UNITED STATES PATENT AND TRADEMARK OFFICE

APPLICATION NO.	FILING DATE	FIRST NAMED INVENTOR	ATTORNEY DOCKET NO.	CONFIRMATION NO.
10/673,643	09/30/2003	Victor T. Massey	081589-0306133	1141

Office Action Summary

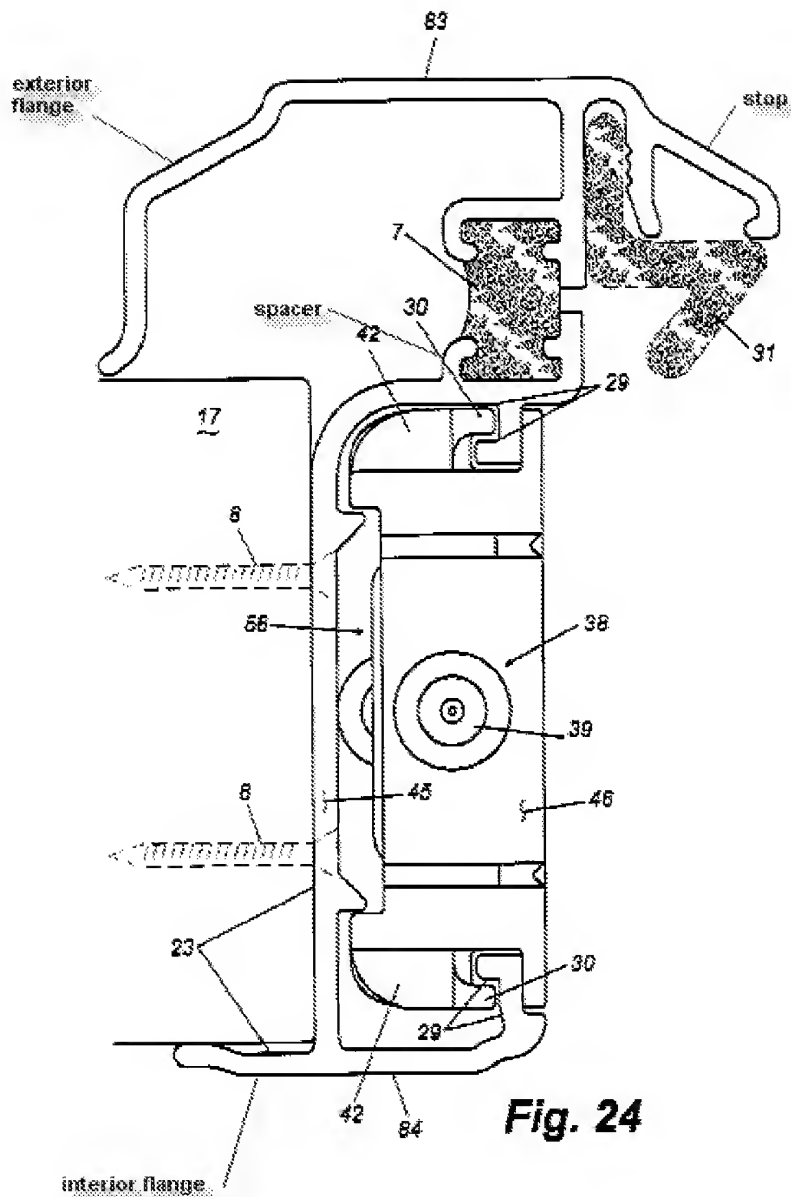
Claims 1-21, 39 and 47 are rejected under 35 U.S.C. 103(a) as being unpatentable over Massey et al. (6491326) in view of Hendrickson et al. (US 6684571) and Davis (US 3364624). Massey et al. discloses an astragal assembly 27 for attachment to a passive door 17 having an interior surface, an exterior surface opposite to the interior surface, and an outer edge extending from the exterior surface to the interior surface, comprising: a frame 28 having an exterior portion 83, an interior portion 84 spaced from and opposed to the exterior portion, and a side portion 45 extending between the exterior portion and the interior portion disposed opposite the outer edge of the passive door when the astragal assembly is affixed thereto, a gasket 7 interconnected between said exterior portion and said side portion, an interior flange (labeled below) extending away from where said interior portion meets said side portion to engage the interior surface of the passive door when the astragal assembly is affixed thereto, and an exterior flange (labeled below) opposite said interior flange and extending away from where said exterior portion is connected to said gasket 7 to engage the exterior surface of the passive door when the astragal assembly is affixed thereto, wherein an elongated open channel is defined in the frame with sides formed by the exterior portion and the interior portion and a base formed by the side portion, the elongated open channel having an opening extending between the exterior portion and the interior portion and opposed to the side portion; and an insert 25 retained within the elongated open channel in the frame, a stop (labeled below), a second gasket 31, a

thermal break 7, hooks 29, a strike plate 21. Massey et al. is silent concerning a spacer and an wooden insert.

Claims 32-35, 37 and 38 are rejected under 35 U.S.C. 103(a) as being unpatentable over Massey et al. in view of Davis. Massey et al. discloses an astragal 27 comprising: a frame 28 including an exterior portion 83, an exterior flange (labeled above) extending from a first side of said exterior portion, and a stop (labeled above)

wherein the exterior portion includes a hollow section (not numbered, but defined between the exterior flange and the thermal break 7) and a hook 29 extending into the channel that retains the insert member;

wherein the interior portion 84 includes a thin wall with a hook 29 extending into the channel that retains the insert member;

wherein the side portion includes a thermal break 7;

further comprising a strike plate 21 secured to the insert member;

wherein the frame 28 has a generally U-shaped cross section, with the side portion including a fastening formation 24 that attaches to a door edge such that the U-shaped cross section faces outward from the door edge.
